3 May 2022

17156

SECTION 4.55(1A) MODIFICATION APPLICATION - SSD 8903 Stage 1 of Ivanhoe Estate (Midtown), Macquarie Park

Figure 1 Structural roots and tree branches growing into the FPA site and area of approved works

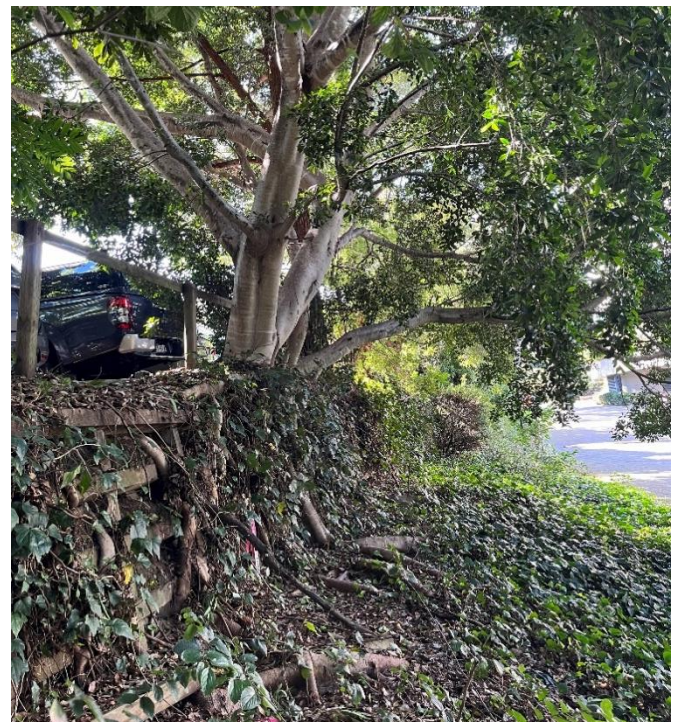
The original assessment (ELA 2020; AIA v6) indicated that these trees in question could be retained as they were located above a crib wall, situated 2+metres above the proposed works footprint. Based on the detailed plans (ADW Johnson 2018), disturbance of the structural root zone was not expected to occur.

However, due to changes in the ground level necessary to facilitate the provisions of the new roadway between Main Street and Lyonpark Road (approved as part of the Concept Masterplan and Stage 1 SSDA), excavation of the embankment adjacent to the crib wall is required to a depth of approximately 3 metres from the current level which would result in significant impacts to the structural root zone of these the seven (7) trees along this wall. This is compounded by the growth of the trees, which have adapted to their surrounds and have grown over the crib wall and into the embankment within the Ivanhoe Estate site.

Figure 3 *Trees subject to this application (outlined)*

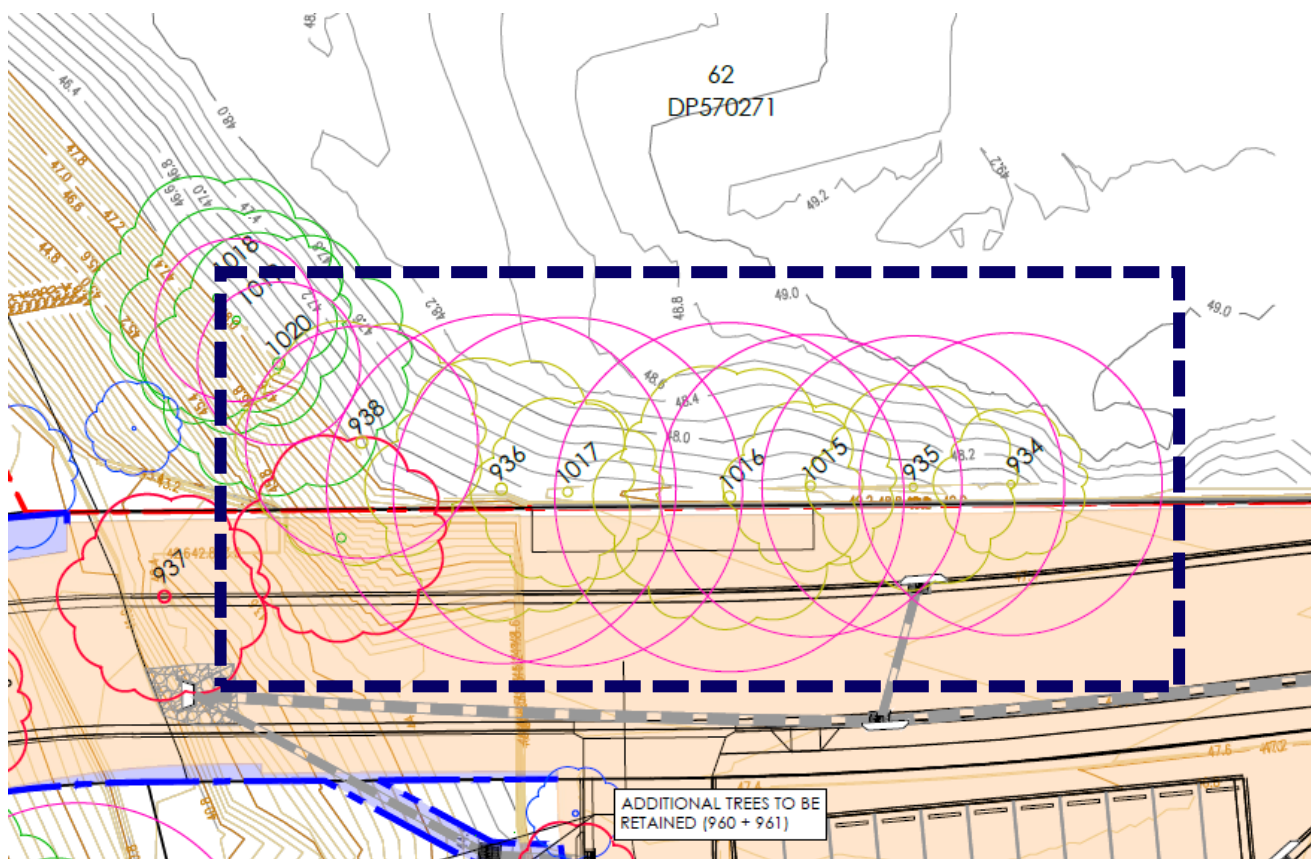
Stage 1 of the Ivanhoe Estate redevelopment approves the removal or retention and protection of trees as part of site preparation works occurring across the site. However, through post-approval design development and testing, changes are required to these approved works to enable the removal of seven (7) trees associated with the delivery of a bridge and road connection to Lyonpark Road.

Photographs of the existing wall and trees are shown below. An extract of the tree retention and removal plan showing the location of these trees is provided at **Figure 3**.

Drawing No.	Revision	Name of Plan	Date
300001-ESK-213	E	Tree Retention Plan	02/05/2022

A29. All tree removal must be consistent with Table 3 and drawings in Appendix C, contained in the Arboricultural Impact Assessment, prepared by Eco Logical Australia, dated February 2020, as modified by 300001-ESK-213 Revision E dated 02/05/2022.
